**South Carolina Electric & Gas Company**  
**Virgil C. Summer Nuclear Station (VCSNS) Units 2 and 3**

**License Amendment Request:**  
**Auxiliary Building Structural Floor and Roof Details**  
**(LAR 14-01)**

**Proposed Changes to Licensing Basis Documents**  
**(LAR 14-01)**

**UFSAR Chapter 3, Appendix 3H, Figure 3H.5-6, [*Auxiliary Building Typical Composite Floor*]\* - Revise Tier 2\* information as shown in the figures following this page. A separate sheet displaying the notes proposed to be added to this figure is provided to aid in review of the proposed changes.**

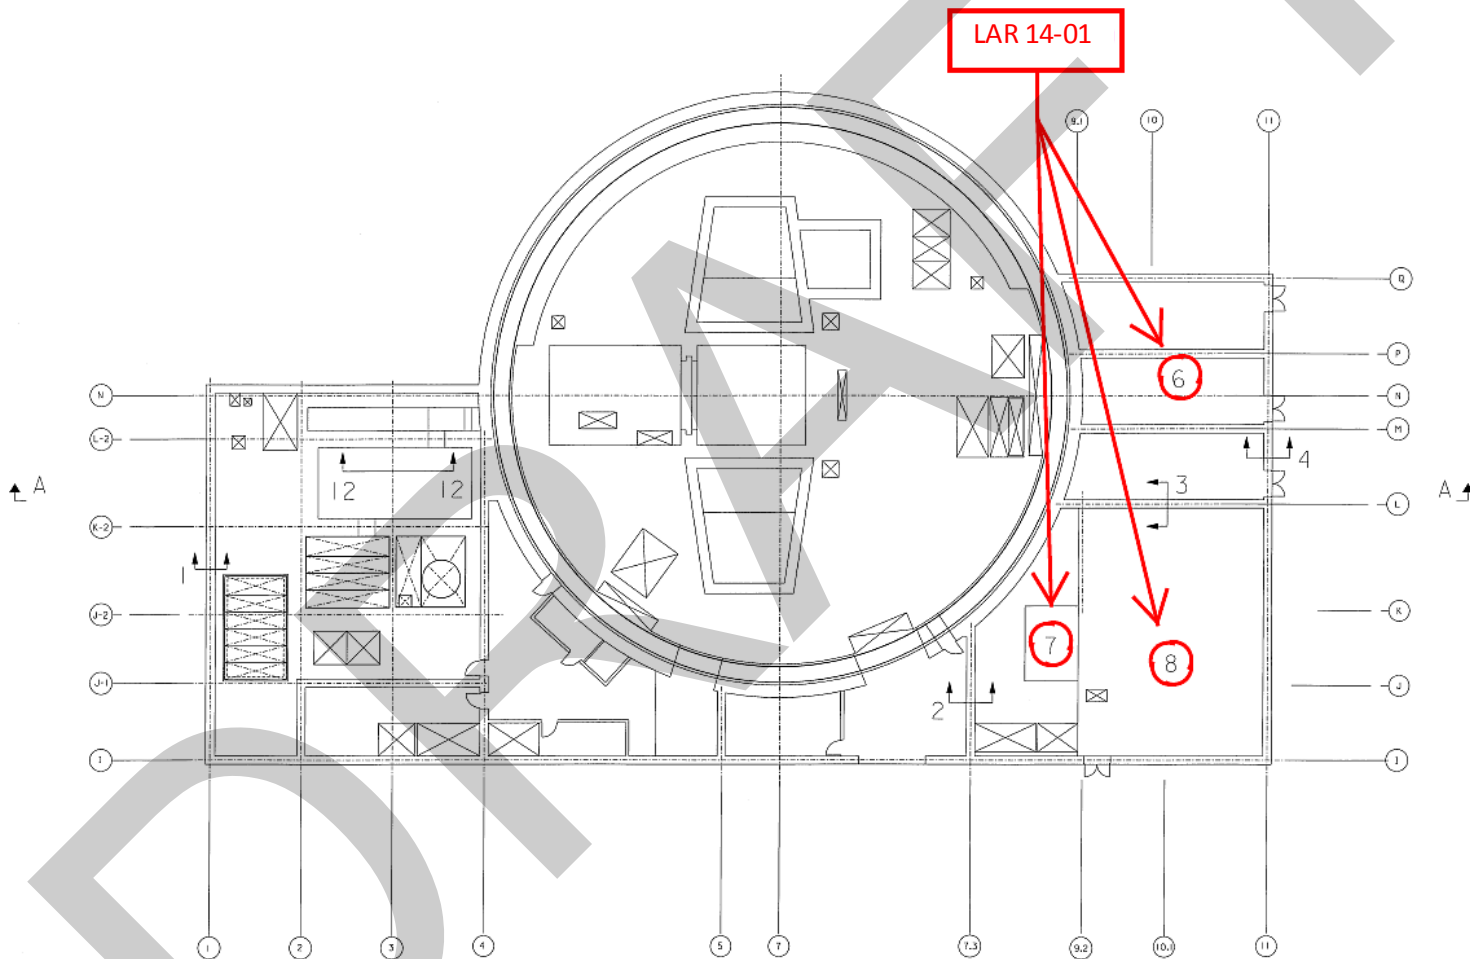
- 1) Detail shown is specific to the composite floor at El. 135' -3" at intersection with Wall M. Refer to Subsection 3H.5.2 and other notes for additional information about design details for other floor sections.

- 2) [Previous Note 1 renumbered to Note 2.]
- 3) Floor beam size and spacing are designed based on floor load and geometry to satisfy AISC N690 requirements. The beam sizes used are predominately W14x26 and W14x48. The range of beam sizes is from W10 to W44. The spacing between the beams is predominately in a range of 5 to 6 feet.

- 4) The reinforcement shown is for locations away from openings, penetrations, embedments, and other obstructions.
- 5) Reinforcement size and spacing are based on the requirements in ACI 349 for flexural reinforcement.

- 6) The adjacent wall may be designed as a structural wall module.
- 7) The detail design, location and embedment of the beam supports are designed to the requirements of AISC N690 and ACI 349 as applicable. Support configuration, including the use of plates, structural shapes, and stiffeners, is based on loading and local geometry considerations. The design of embedment anchorage including type, size, and spacing satisfies the requirements of Appendix B as well as other applicable sections of ACI 349.

**UFSAR Figure 3H.5-1 (Sheet 2 of 3) markups**

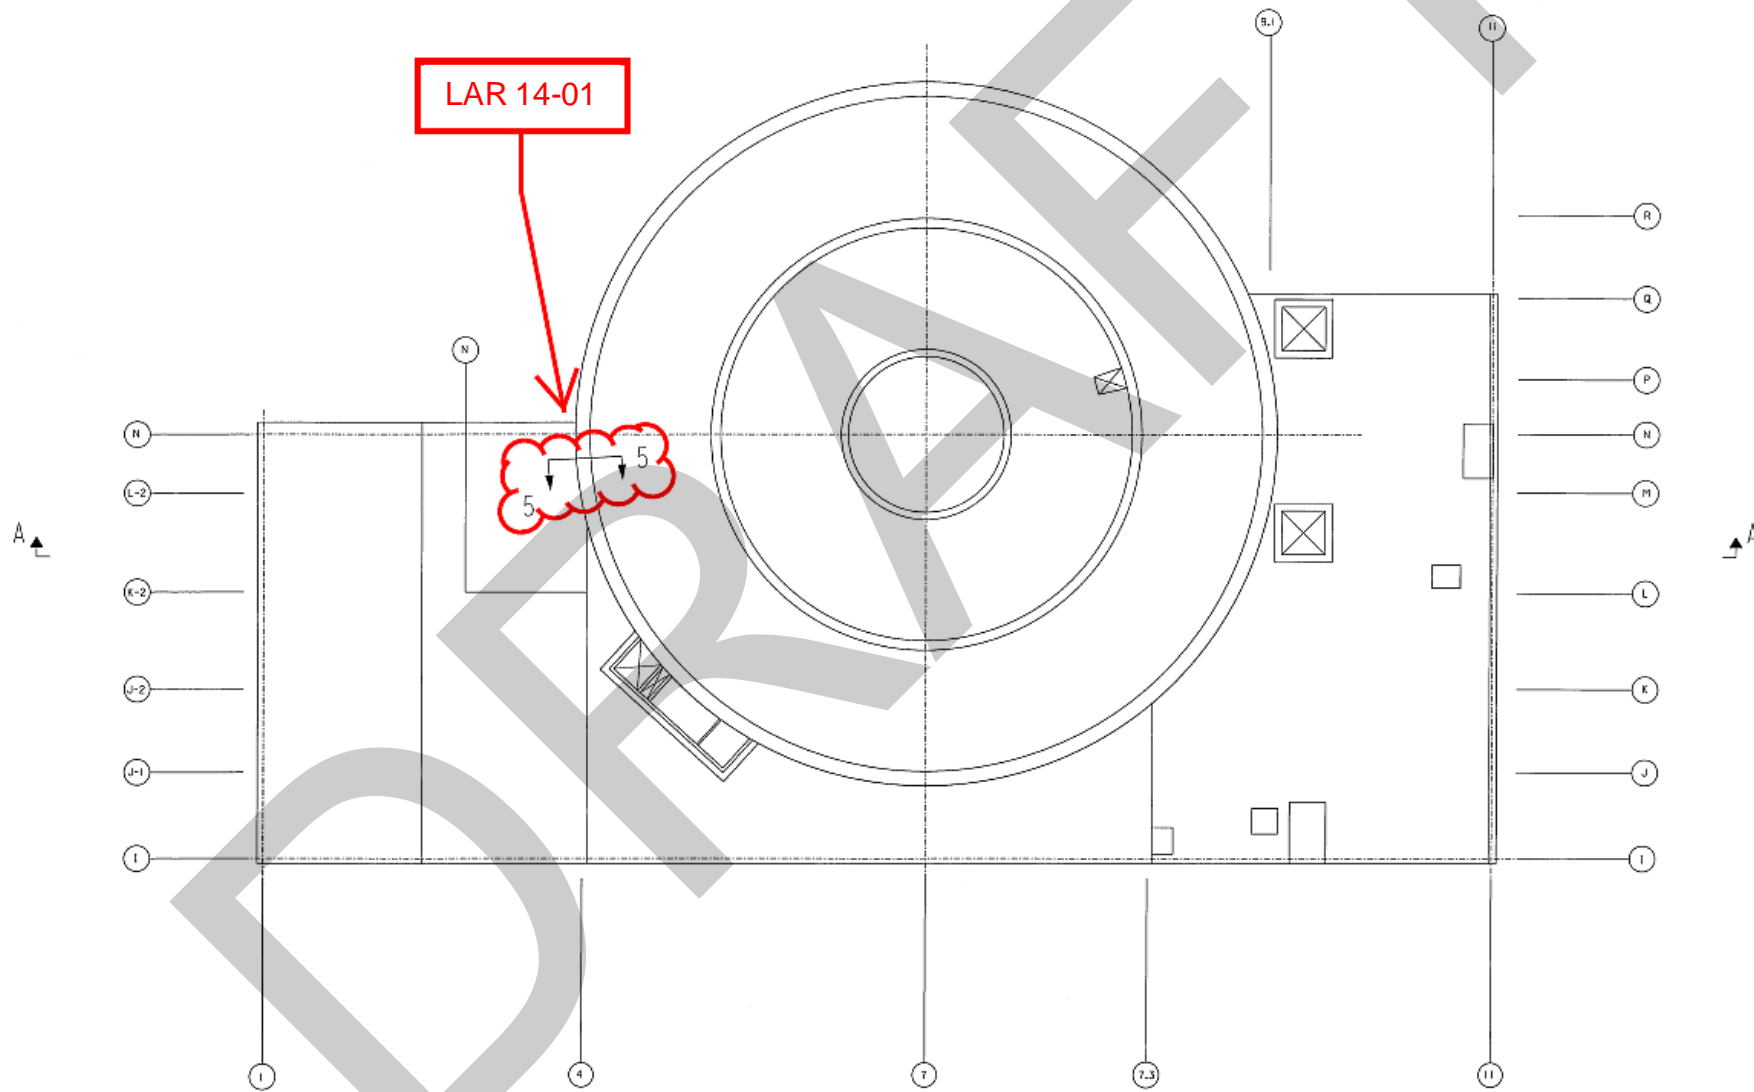
The change to Figure 3H.5-1 is an administrative change so that the labels on the figure conform to the Item numbers in the list in UFSAR Subsection 3H.5-1. This change does

**UFSAR Chapter 3, Appendix 3H, Figure 3H.5-1 (Sheet 2 of 3), [*Nuclear Island Critical Sections Plan at El. 180'-0"*]\* - Revise critical section indications to better match Subsection 3H.5.**

UFSAR Figure 3H.5-6 markups

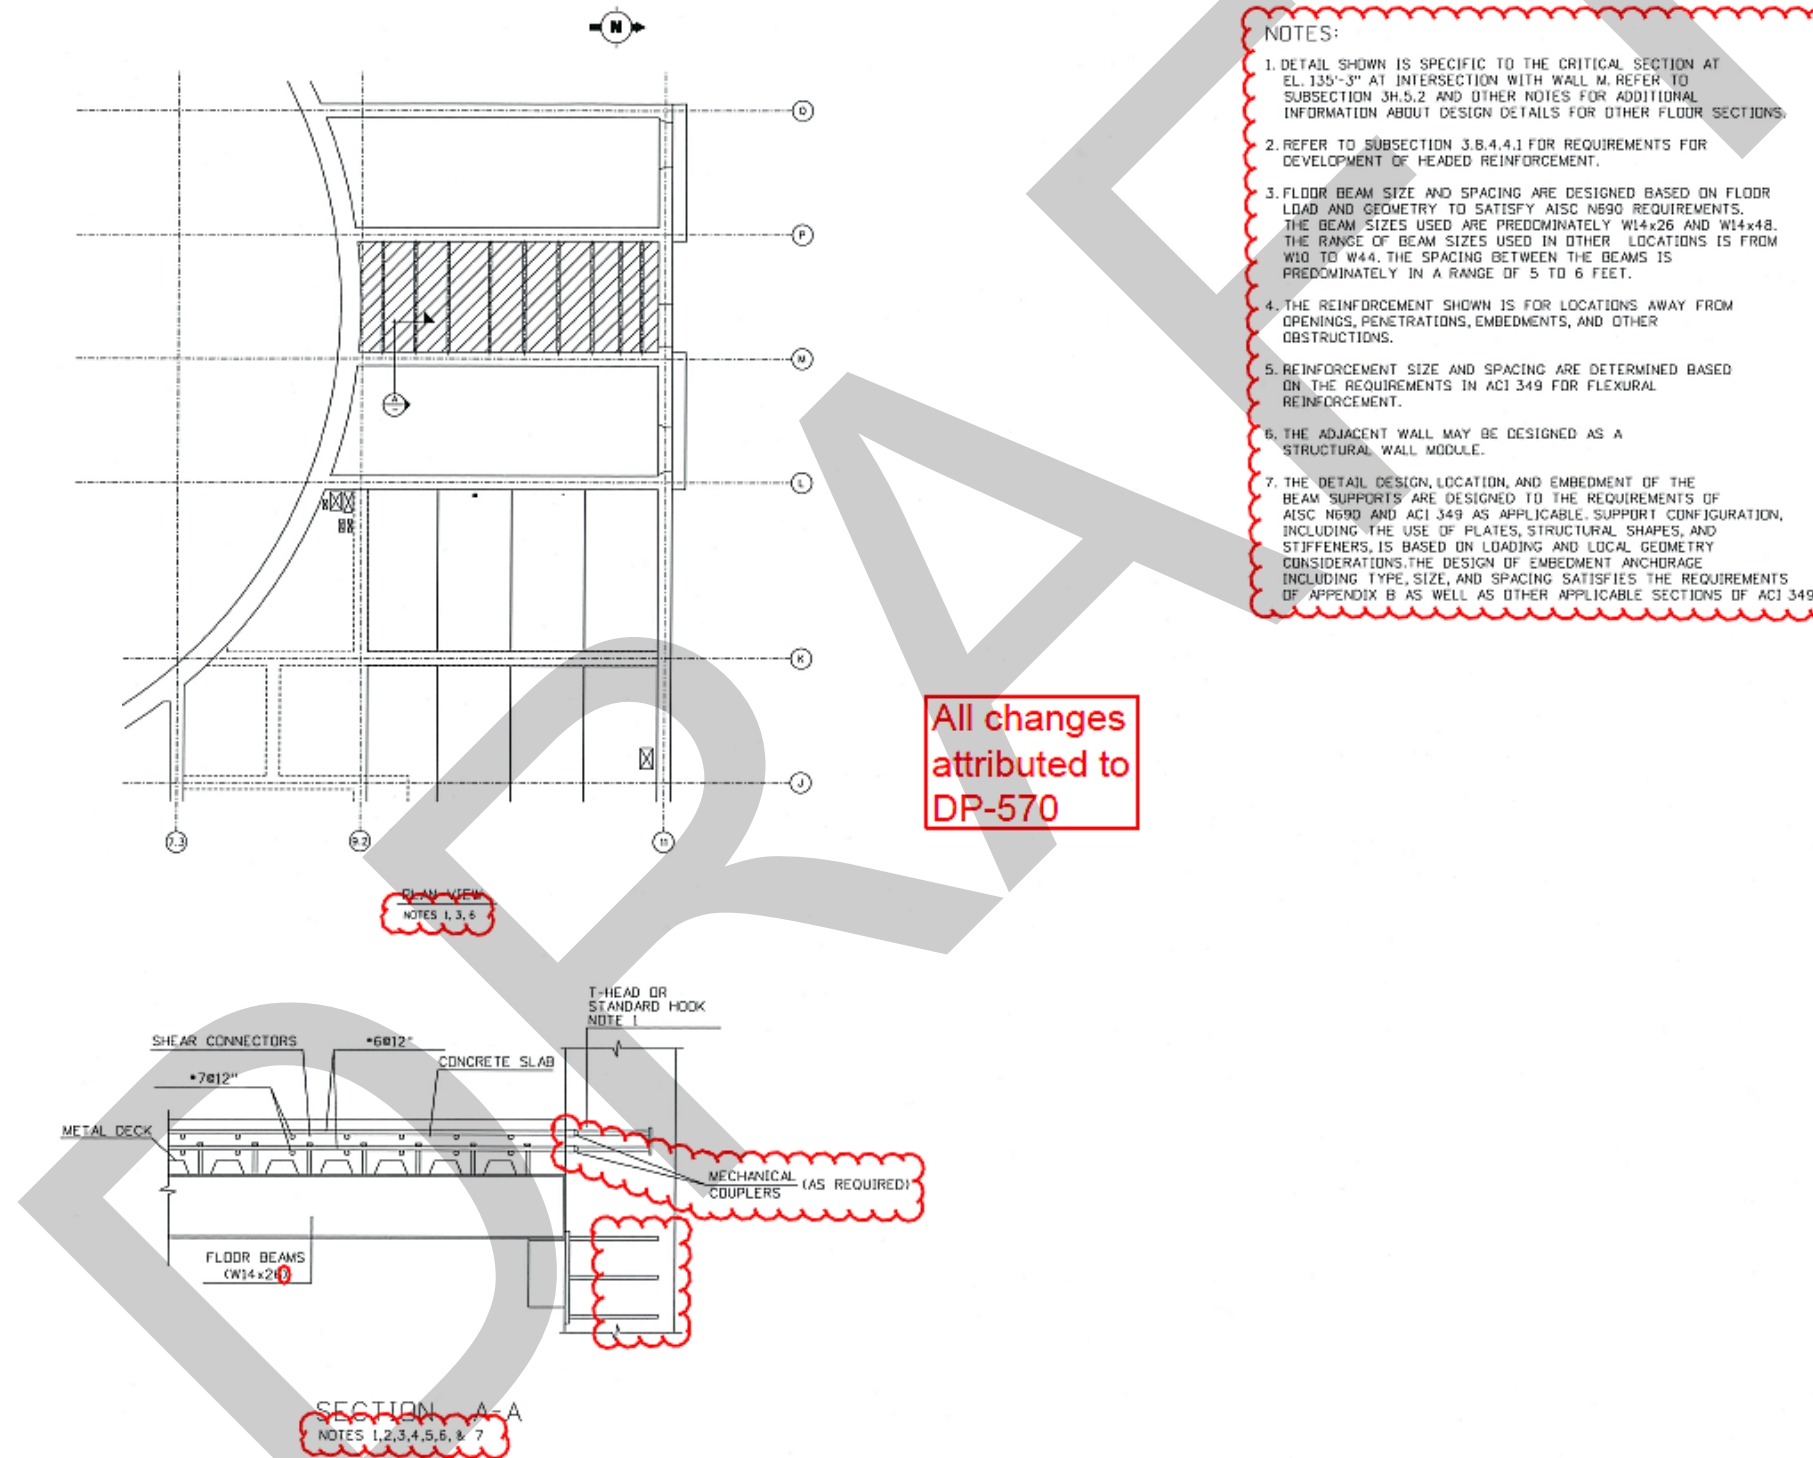
The addition of 2.5 inch metal decking to the design of the metal decking in a composite floor, concrete over metal decking, is based on the use of stronger, heavier metal decking where geometry considerations require longer spans between beams. The heavier decking is manufactured with thicker plate and shallower corrugations (ribs). There is no adverse impact on the floor design because the more shallow corrugations result in a thicker floor above the ribs. There is no change in the conformance of the design with the applicable codes and standards.

The design of the supporting beams, beam supports, shear connectors, and the composite action of the floor of concrete on metal decking is evaluated according to the requirements of AISC N690. Predominately the beams used for the composite floor are W14x26 and W14x48. The range of beam sizes used in other locations is from W10 to W44. The smaller beams are used to provide clearance or for very short spans. The heavier beams are used because of heavier loads or longer spans of beams. In a few cases large beams are used where other beams tie into a large beam. The beams usually have a span of 15 to 25 feet with an overall range of spans of 2 feet 6 inches to 38 feet 6 inches. The beam spacing and beam to wall spacing is usually approximately 5 to 6 feet with an overall range of 3 to 8 feet. The variation in the length of spans and spacing between is generally required by the local geometry.

The beam supports and panel supports are shown with deformed wire anchors embedded in the concrete in the revised figures. The deformed wire anchors are used at the critical section as well as other floor sections. The embedment design satisfies the requirements of ACI 349 Appendix B and other sections of ACI 349 as required by Appendix B for deformed wire anchors. The number and spacing of the anchors can be different than that shown in the figure based on local loads. Headed shear studs can be used in lieu of deformed wire anchors. The design of the portion of the support exterior

UFSAR Figure 3H.5-8 markups

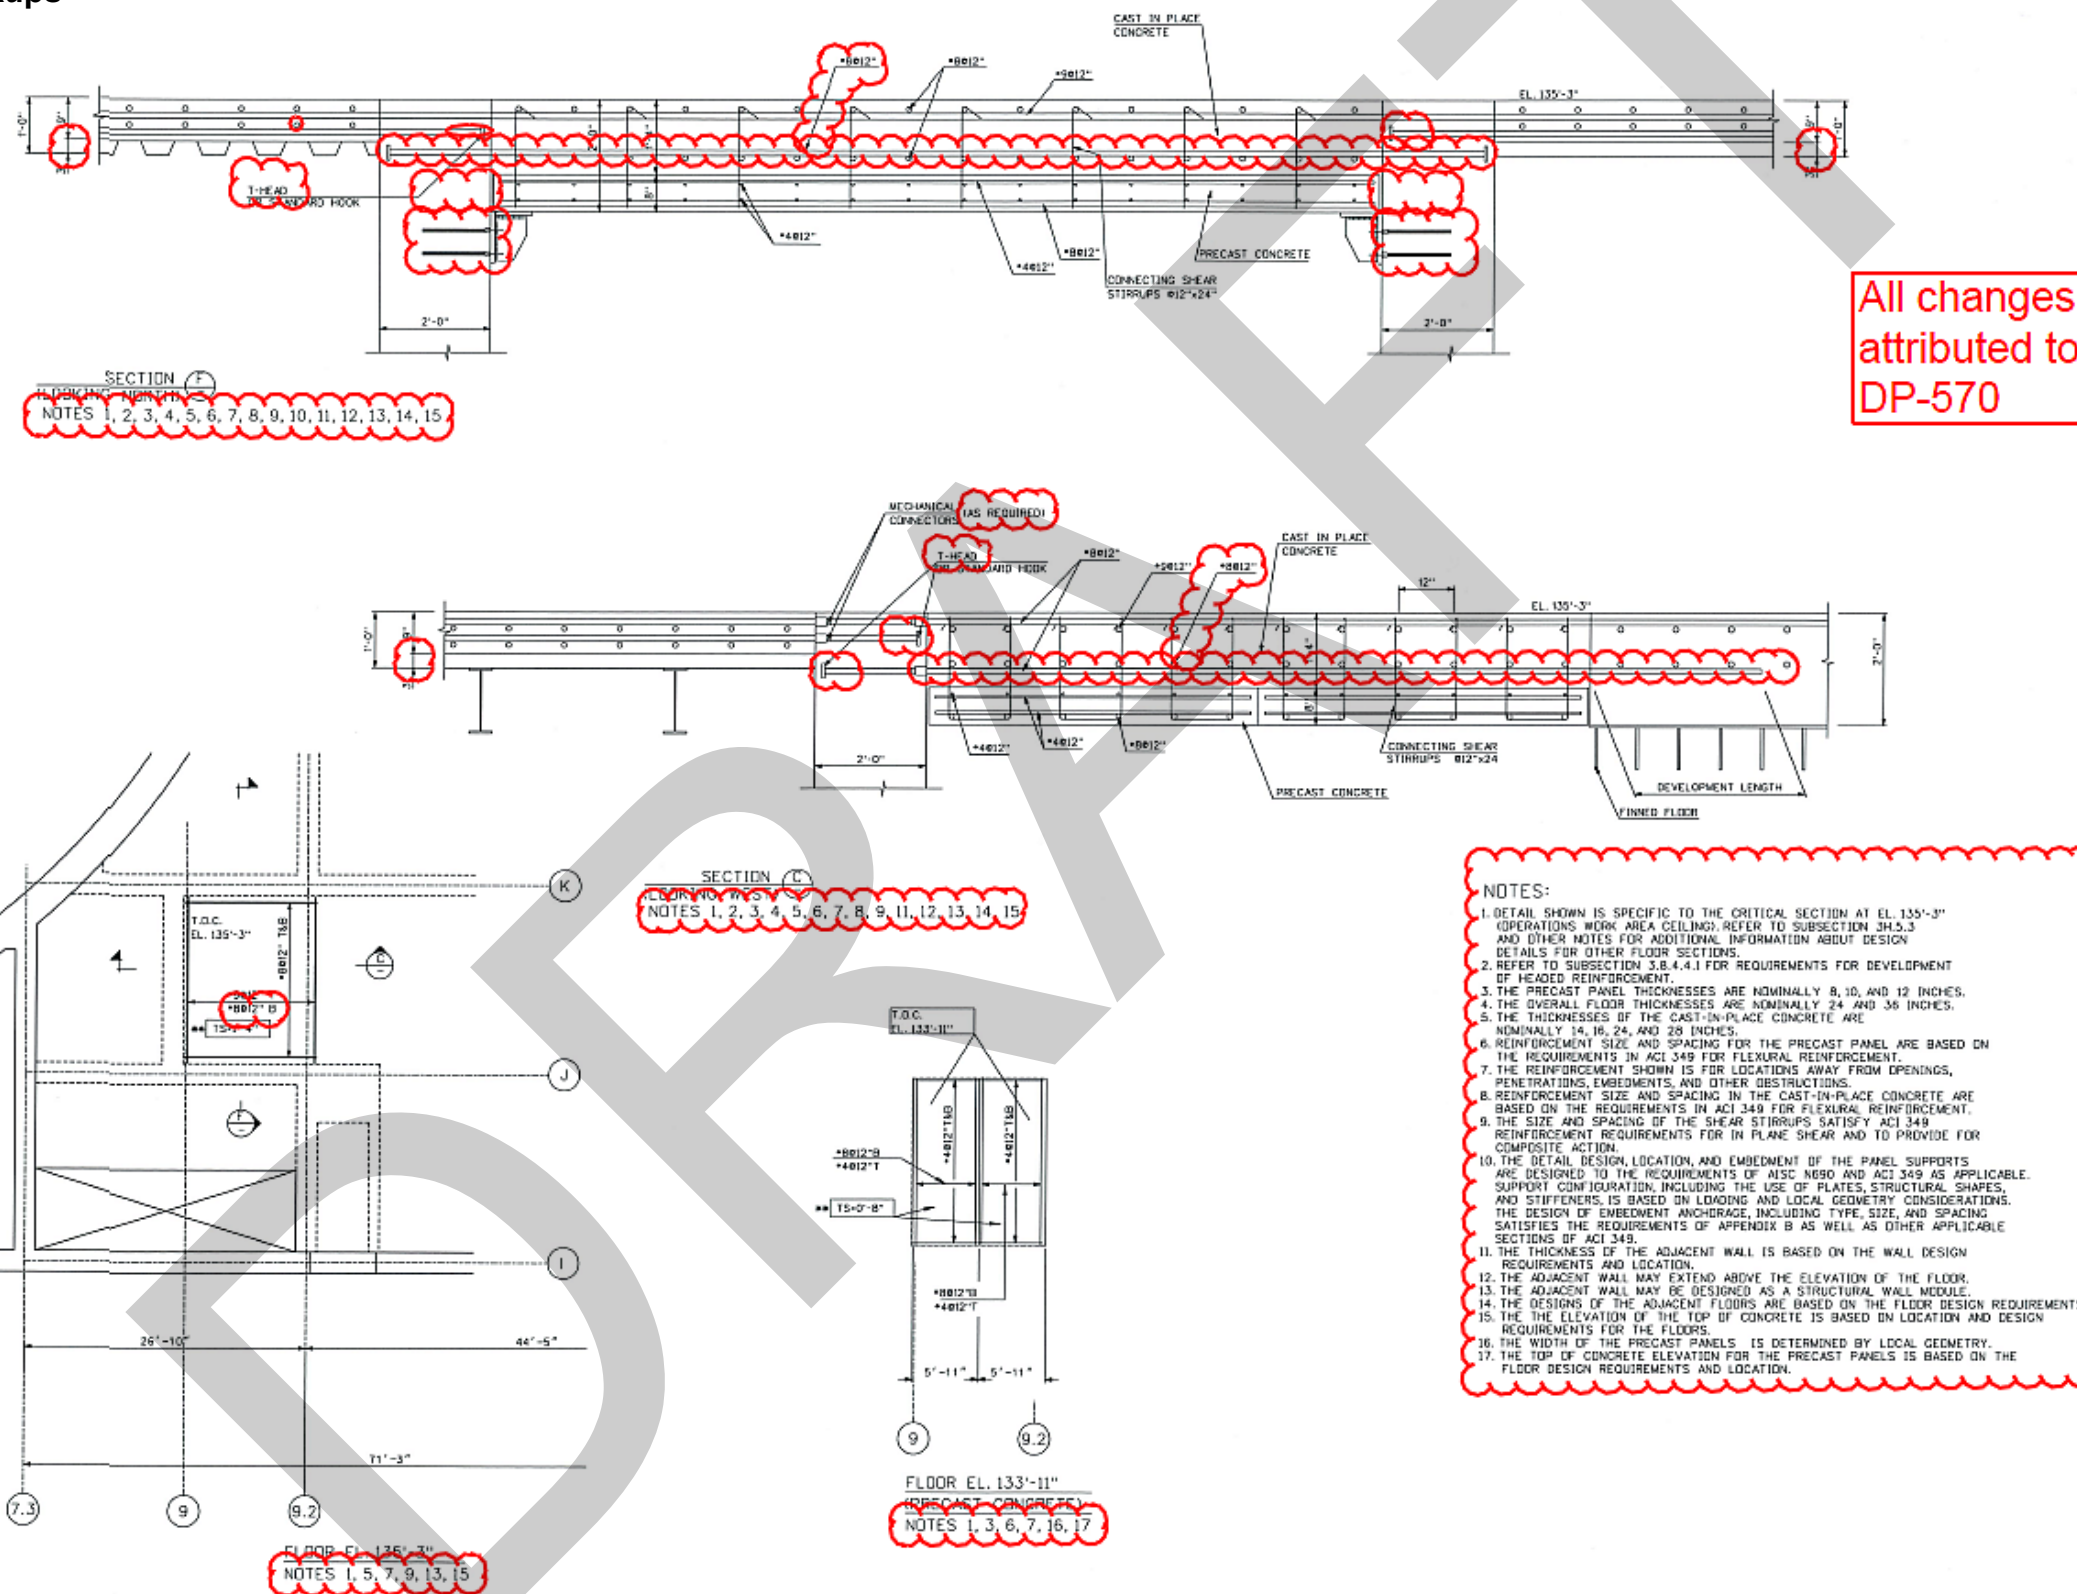
The proposed changes include implementation of requirements for development of headed reinforcement. These changes include, changing the term "Anchor Plates" to "T-Heads", extending the lengths of the reinforcement into the walls, and adding a note to the drawing identifying the requirements for development of headed reinforcement on Figure 3H.5-8. These requirements are based on requirements in ACI 318-11, Section 12.6. The use of these requirements was approved in a previous license amendment and incorporated into Subsections 3.8.3.5, 3.8.4.4.1, and 3.8.4.5.1 of the licensing basis. See SCE&G COL Amendments 2 and 5 (Adams Accession Numbers ML13056A183 and ML13149A314, respectively).

The proposed changes to the reinforcement in UFSAR Figure 3H.5-8 are incorporated to provide reinforcement in the cast-in-place concrete consistent with the analysis to resist the loads in the cast-in-place concrete without relying on the flexural reinforcement in the precast panels. The figure is also revised to make a minor change to be consistent with drawing convention. The revised design is in conformance with ACI 349. The drafting convention changes do not change design information or design requirements. The proposed changes to the detail design of the auxiliary building floors do not change the function, design, or operation of the systems and components supported by the floors in the auxiliary building. The proposed changes do not change the function, design, or operation of the containment vessel and passive containment cooling system. The proposed changes do not affect the prevention and mitigation of abnormal events, e.g., accidents, anticipated operational occurrences, earthquakes, floods and turbine missiles, or their safety or design analyses. The proposed changes do not involve, nor interface with, any structure, system or component accident initiator or initiating sequence of events, and thus, the probabilities of the accidents evaluated in the UFSAR are not affected.

**UFSAR Chapter 3, Appendix 3H, Figure 3H.5-8, [*Auxiliary Building Operations Work Area (Tagging Room) Ceiling*]\* - Revise Tier 2\* information as shown in the figures following this page. A separate sheet displaying the notes proposed to be added to this figure is provided to aid in review of the proposed changes.**

- 1) Detail shown is specific to the reinforced concrete floor at El. 135'-3" (operations work area ceiling). Refer to Subsection 3H.5.3 and other notes for additional information about design details for other floor sections.

- 2) Refer to Subsection 3.8.4.4.1 for the requirements for development of headed reinforcement.
- 3) The precast panel thicknesses are nominally 8, 10, and 12 inches.

- 4) The overall floor thicknesses are nominally 24 and 36 inches
- 5) The thicknesses of the cast-in-place concrete are nominally 14, 16, 24, and 28 inches.
